10.4 Other Features of Steam and Power Conversion

The information in this section of the reference ABWR DCD, including all subsections, tables, and figures is incorporated by reference with the following departures and supplements.

Figure 10.4-1 Main Condenser Evacuation System

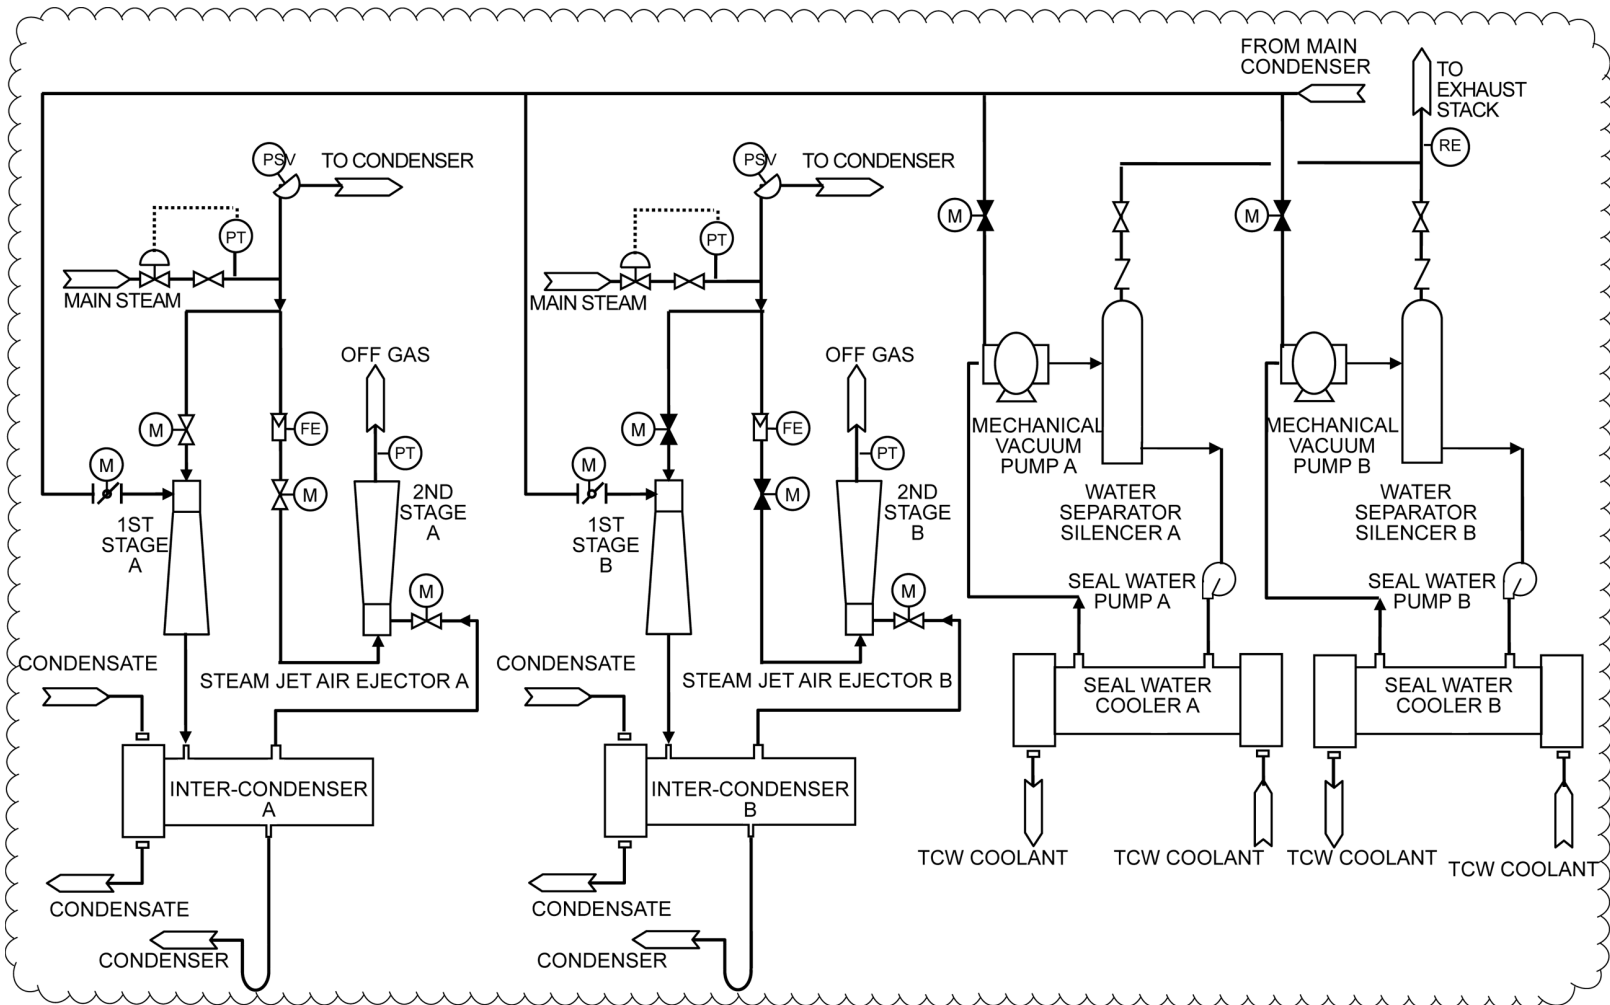
STP DEP 10.4-3 (Table 10.4-2, Figure 10.4-1)

STP DEP 10.4-3

The MCES (figure 10.4-1) consists of two 100%-capacity, double stage, steam jet air ejector (SJAE) units (complete with ~~intercondenser~~ intercondensers) for power plant operation, and ~~a two, 100% mechanical vacuum pump pumps~~ for use during startup. The last stage of the SJAE is a noncondensing stage. One SJAE unit is normally in operation and the other is on standby.

The SJAEs are placed in service to remove the gases from the main condenser after a pressure of about ~~0.034 to 0.051 MPa~~ 7kPa absolute ~~or less~~ is established in the main condenser by the mechanical vacuum pumps and when sufficient nuclear steam pressure is available.

Figure 10.4-2 Turbine Gland Seal System

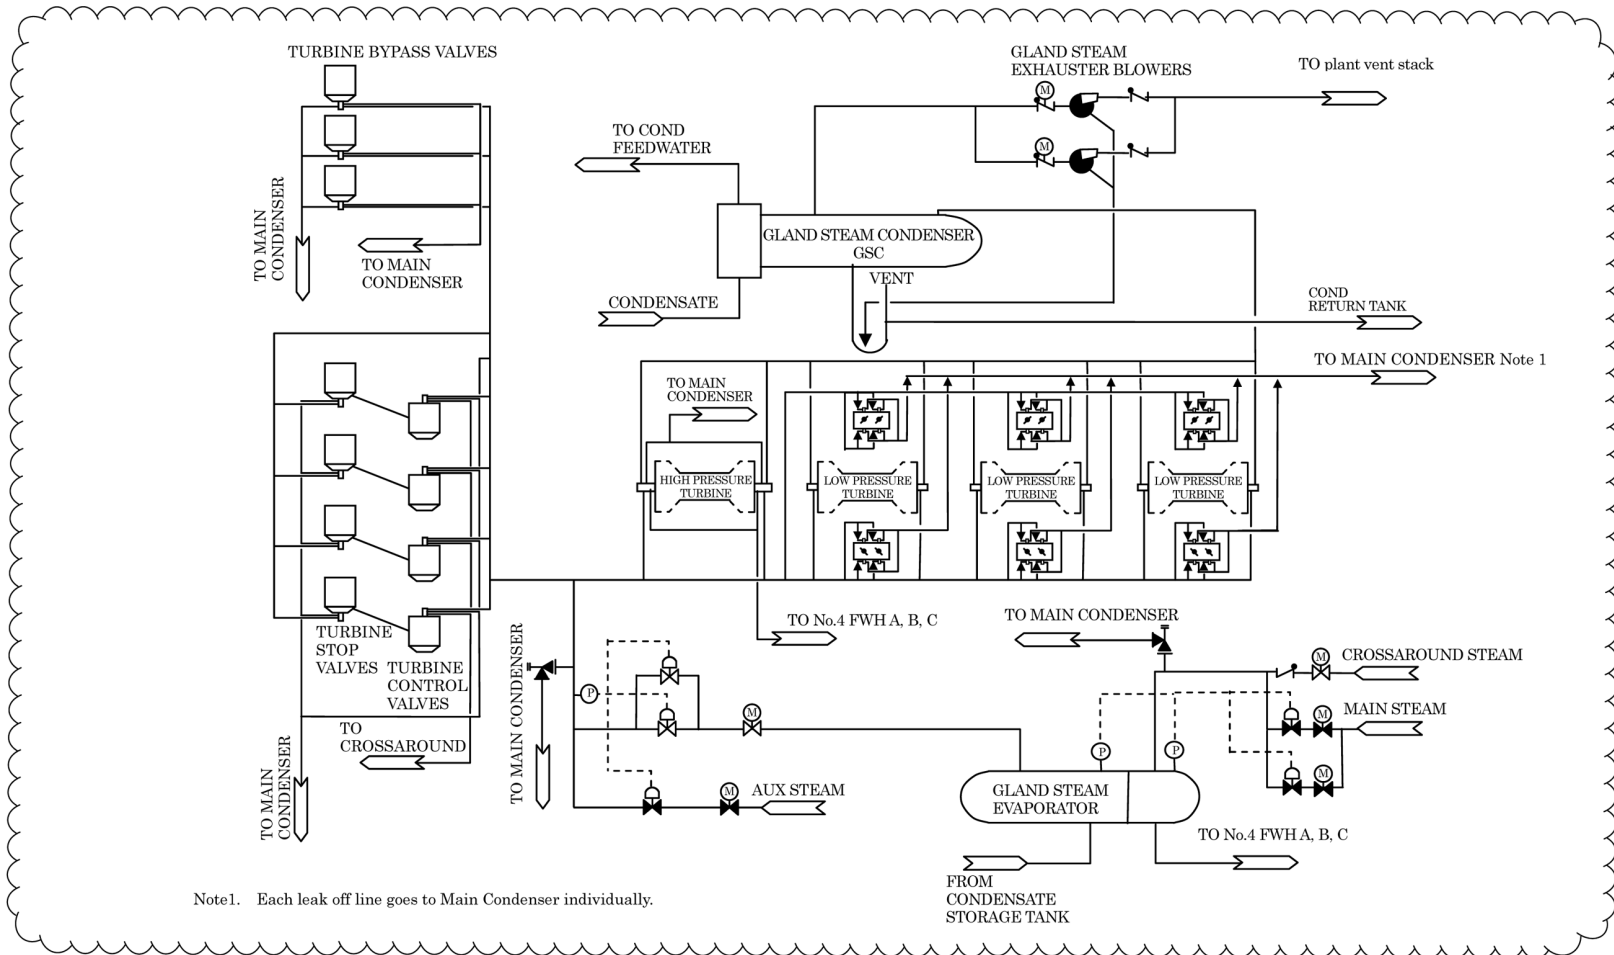
STD DEP 10.4-1 (Figure 10.4-2)

STD DEP 10.4-1

The turbine gland seal system is illustrated in Figure 10.4-2. The turbine gland seal system consists of a gland steam evaporator, sealing steam pressure regulator, sealing steam header, a gland steam condenser with two full-capacity exhausters blowers, and the associated piping, valves and instrumentation.

Figure 10.4-3 Circulating Water System

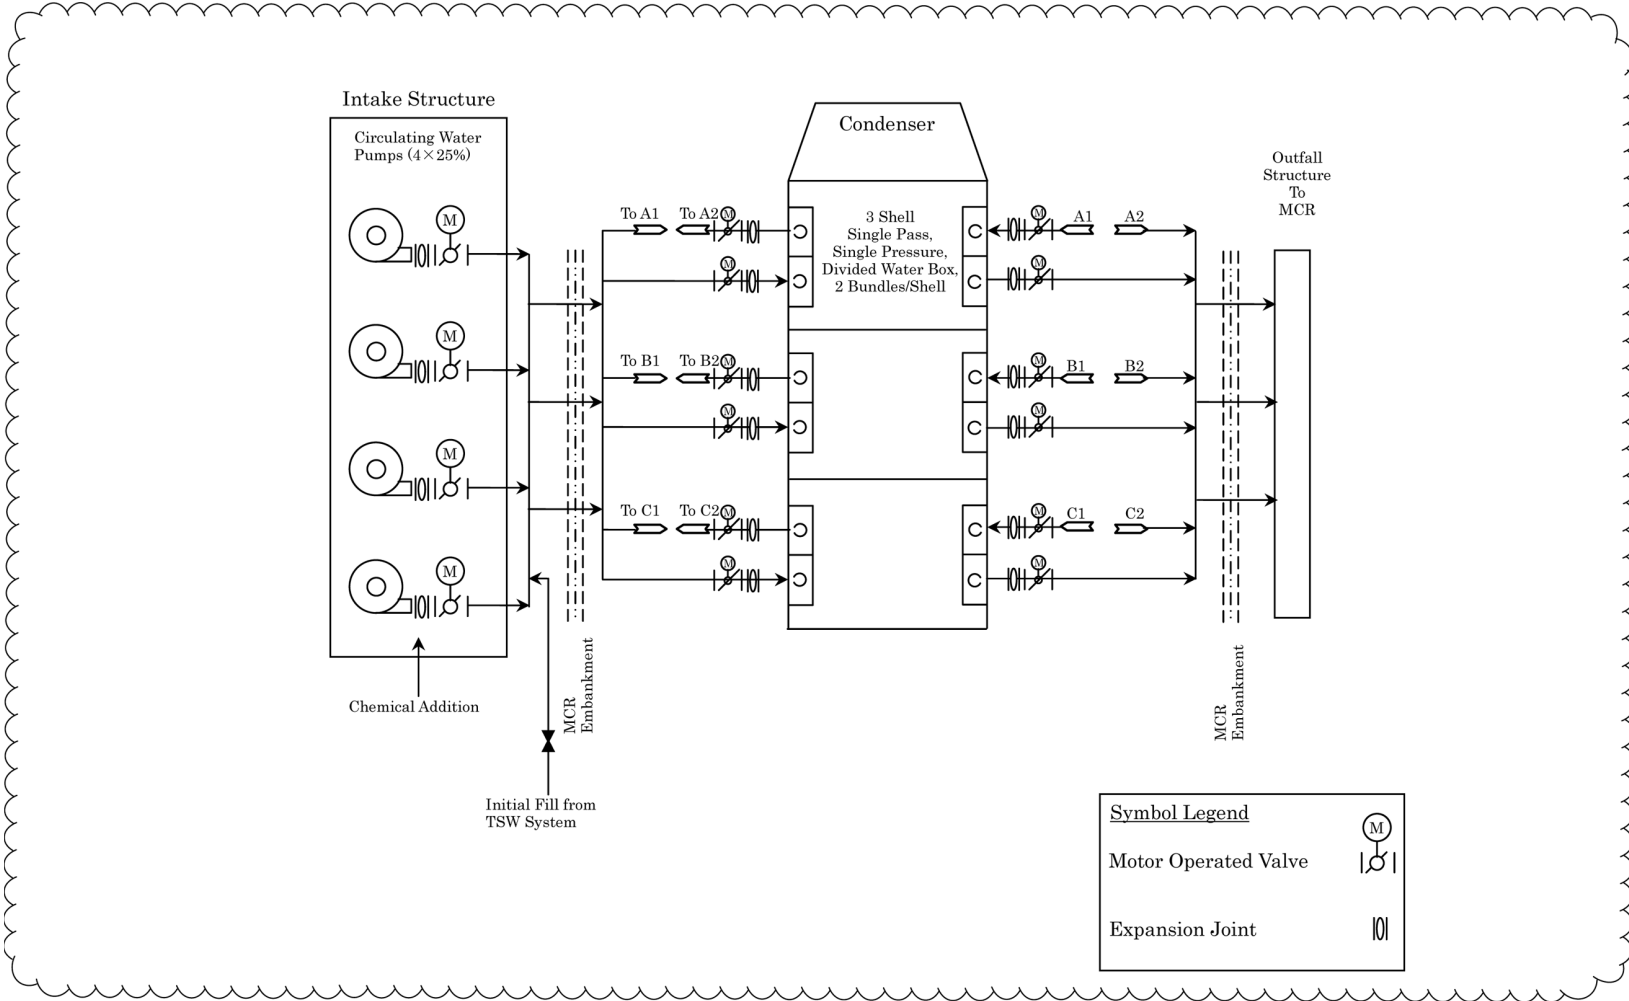
STP DEP 10.4-2 (Table 10.4-1, Table 10.4-3, Figure 10.4-3)

STP DEP 10.4-2

The Circulating Water System (Figure 10.4-3) consists of the following components: (1) ~~screen house~~ intake structure and intake screens, pumps, (2) condenser water boxes and piping and valves, (3) tube side of the main condenser, (4) water box fill and drain subsystem, and (5) related support facilities such as for system water treatment, inventory blowdown and general maintenance.

The cooling water is circulated by ~~at least three~~ four 25% capacity fixed speed motor-driven pumps per unit.

Four 25% capacity fixed speed circulating water pumps per unit discharge into a common header shown in Figure 10.4-3. The discharge of each pump is fitted with a motor operated butterfly valve. The circulating water is pumped through the main condenser and back to the MCR via a discharge outfall at a nominal rate of 272,550 m³/h per unit. To provide capability for condenser waterbox isolation, isolation valves are located on the circulating water inlet and outlet lines.

Figure 10.4-5 Condensate System

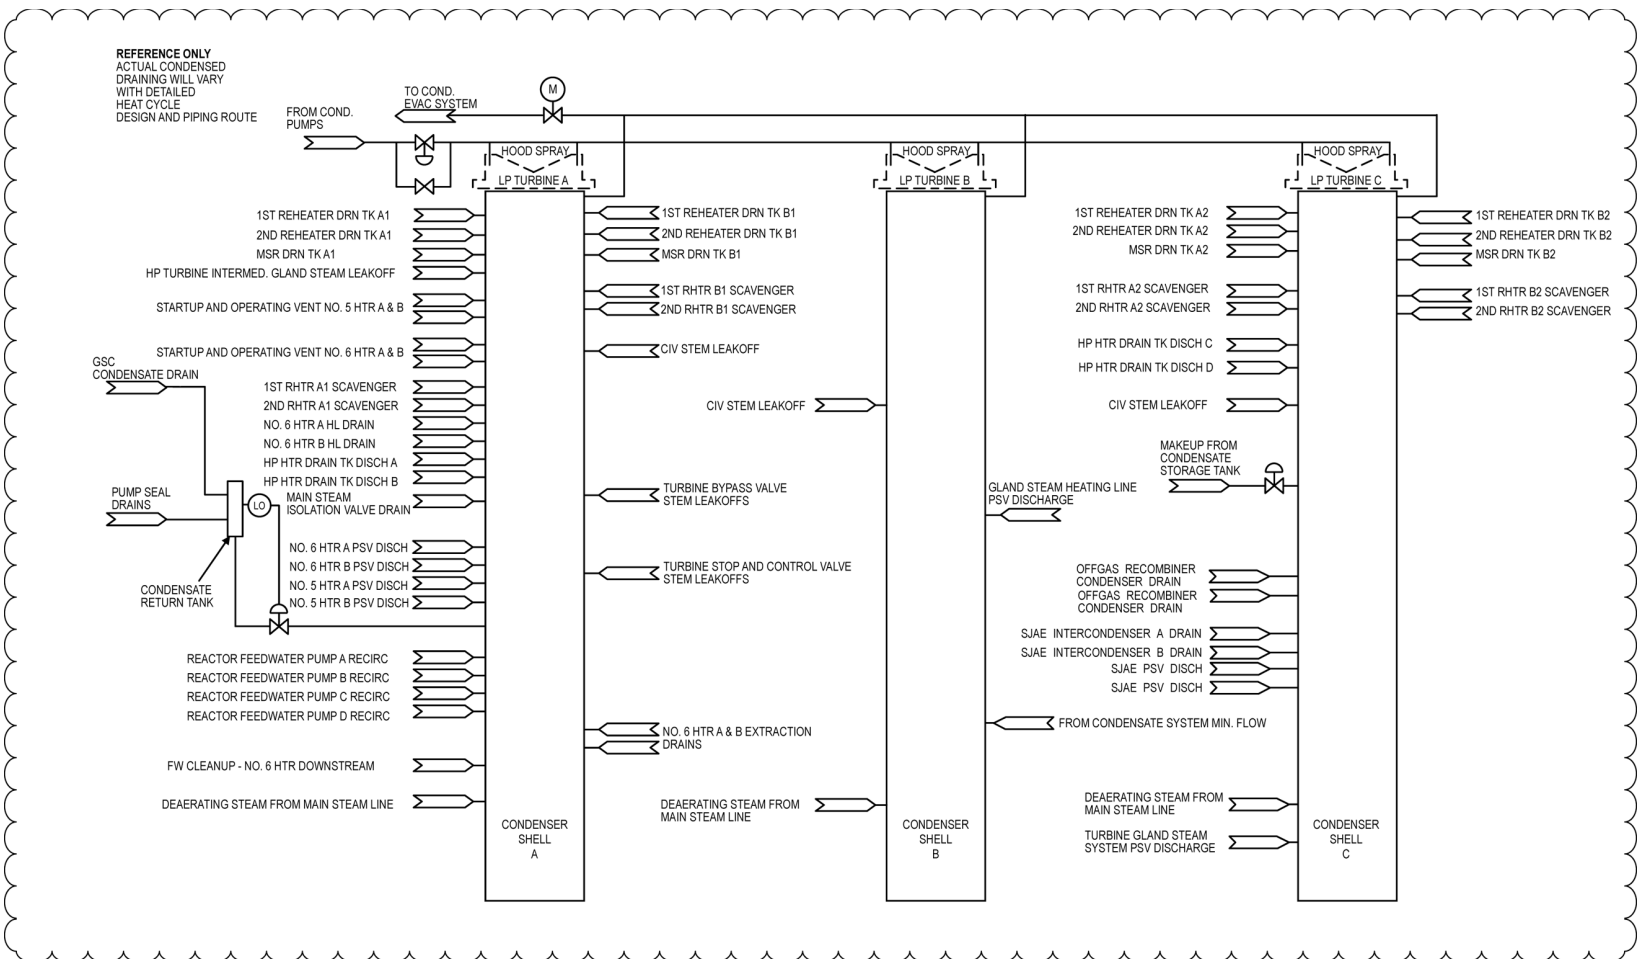
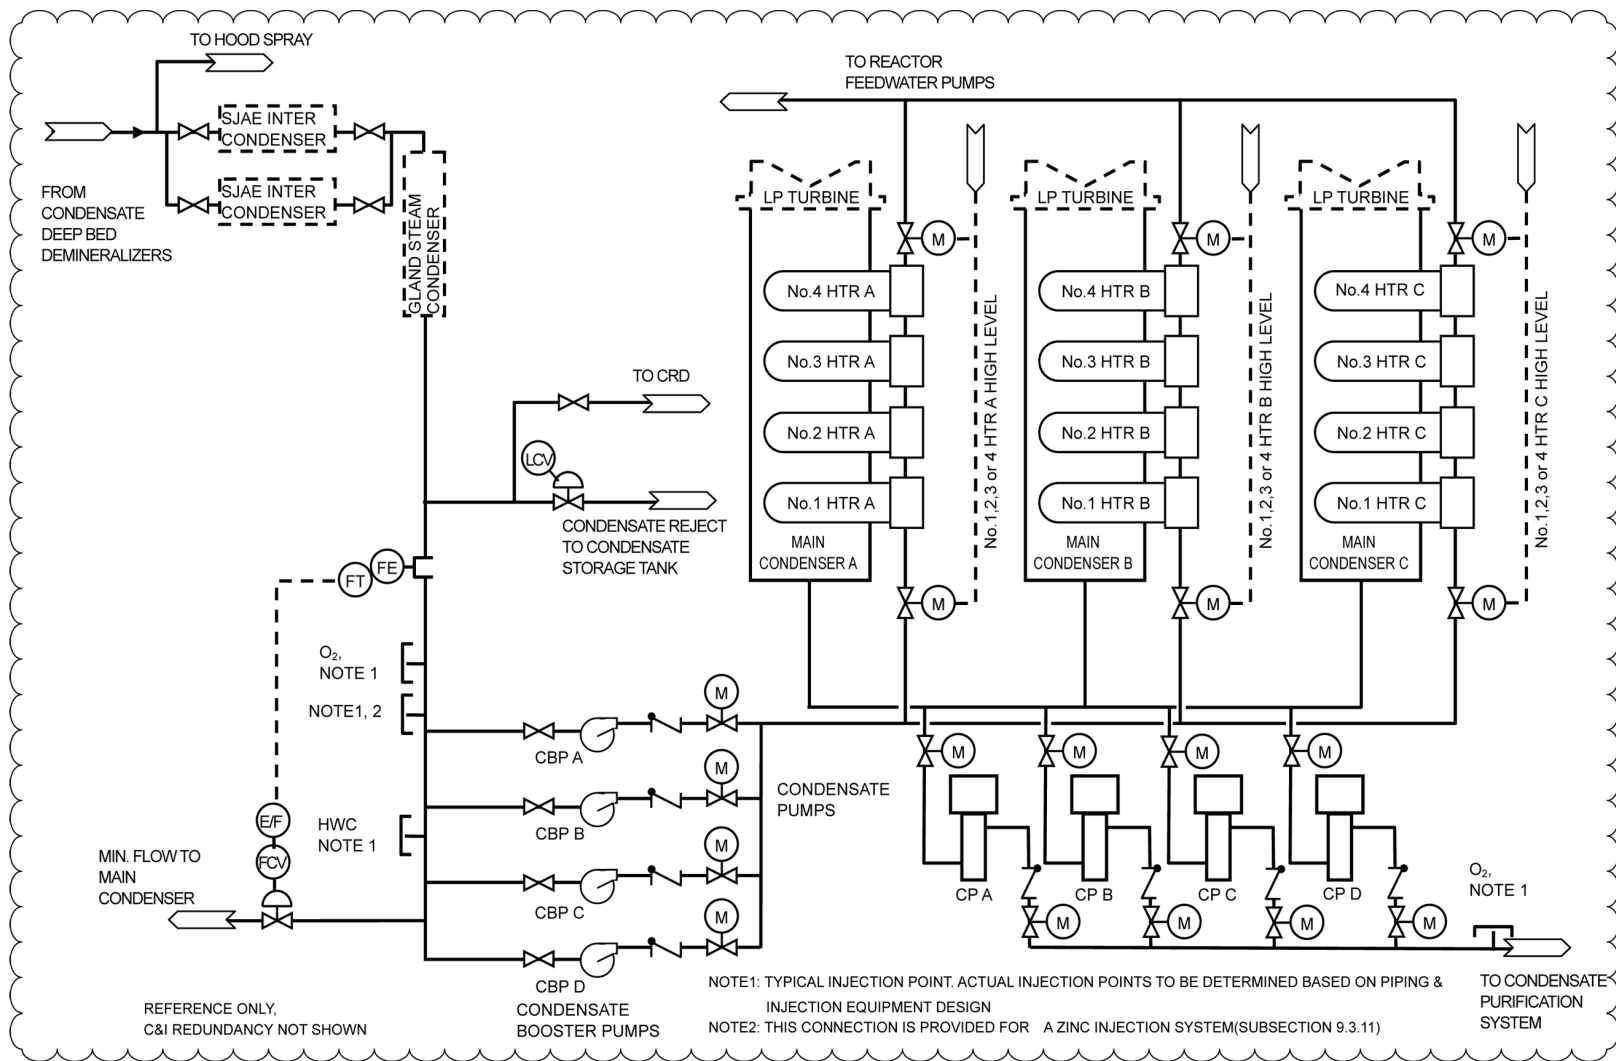
STD DEP 9.2-3 (Figure 10.4-5)

STD DEP 10.4-5 (Tables 10.4-4, 10.4-5 and 10.4-6, Figures 10.4-5, 10.4-6, 10.4-7, and 10.4-8)

STD DEP 10.4-5

The Condensate and Feedwater System (Figures 10.4-5 and 10.4-6) consists of the piping, valves, pumps, heat exchangers, controls and instrumentation, and the associated equipment and subsystems which supply the reactor with heated feedwater in a closed steam cycle utilizing regenerative feedwater heating. The system described in this subsection extends from the main condenser outlet to (but not including) the seismic interface restraint outside of containment. The remainder of the system, extending from the restraint to the reactor, is described in Chapter 5. Turbine cycle steam is utilized for a total of six stages of closed feedwater heating. The drains from each stage of the low-pressure feedwater heaters are cascaded through successively lower pressure feedwater heaters except the lowest and second lowest pressure feedwater heaters which drain to the low pressure heater drain tanks for each string. The drains from each low pressure heater drain tank flow into the external drain coolers of each lowest pressure feedwater heater and finally to the main condenser. The high pressure heater drains are pumped backward to the reactor feedwater pumps suction. The cycle extraction steam, drains and vents systems are illustrated in Figures 10.4-7 and 10.4-8.

The CFS consists of four ~~33-50%~~ 33% capacity condensate pumps (three normally operating and one on automatic standby), four 33% capacity condensate booster pumps, (three normally operating and one on automatic standby). ~~three normally operated 33-65%~~ four 33% capacity reactor feedwater pumps (three normally operating, one on automatic standby), four stages of low-pressure feedwater heaters, and two stages of high- pressure feedwater heaters, piping, valves, and instrumentation. The condensate pumps take suction from the condenser hotwell and discharge the deaerated condensate into one common header which feeds the condensate filter/demineralizers. Downstream of the condensate demineralizers, the condensate is taken by a single header and flows ~~in parallel through five~~ through the auxiliary condenser/coolers, one gland steam exhauster condenser, and two sets of SJAE condensers, ~~offgas recombiner condenser (coolers).~~ The condensate then branches into three parallel strings of low pressure feedwater heaters. Each string
